10/807,213

Office Action Summary

DETAILED ACTION

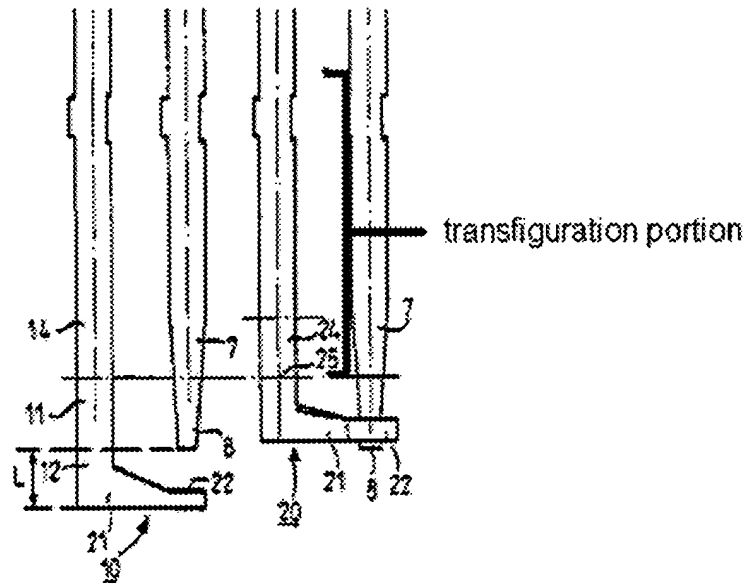
Pernet discloses a switching terminal comprising: a carrier strip (2); a first terminal (5) extending from an edge of the carrier strip; and a second terminal (4) extending from the edge of the carrier strip, being substantially parallel to the first terminal and having a cutout defined in an edge (in right edge). Regarding the recitation "to absorb distortion", please note that a recitation of the intended use of the claimed invention must result in a structural difference between the claimed invention and the prior art in order to patentably distinguish the claimed invention from the prior art. If the prior art structure is capable of performing the intended use, then it meets the claim. See further discussion in section Response to Arguments.

Regarding claim 4, Pernet discloses the second base section comprises a transfiguration portion (part at 24, see following figure), a pressing portion (near 22) and

an angled portion (at 21) interconnecting the transfiguration portion and the pressing portion.

Regarding claim 5, Pernet discloses the cut out being defined in the transfiguration portion (see previous figure).

Regarding claim 6, Pernet discloses the transfiguration portion being deflected outwardly (left in Fig.2b-1) for the position of the cut out.
